**SCAP REFERRAL – Regulation 23 (2) (b) - COUNCIL COMMENTS  
DA 22043120 – 119 Greenhill Road Unley**

*“7 level residential flat building with associated carparking and landscaping”*

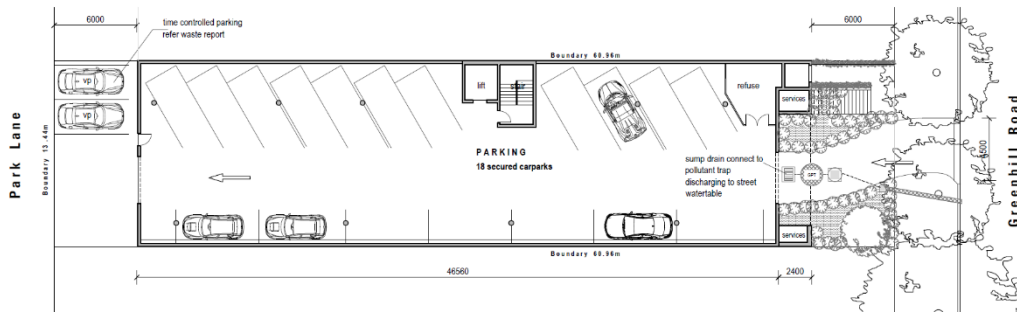
- The building is at grade level with an area for landscaping to the front, with around 45m<sup>2</sup> exposed deep soil (require 7% or 57m<sup>2</sup> of deep soil). The natural deep soil and tree roots could expand under the building to support the landscaping and the one required medium size tree (6-12m tall and 4-8m canopy spread). The species of Japanese Maple is not specified to ensure the appropriate size.

Further, there is no softening landscaping to the rear resulting in a harsh fully paved area to the rear lane (also see Waste Management and Servicing);
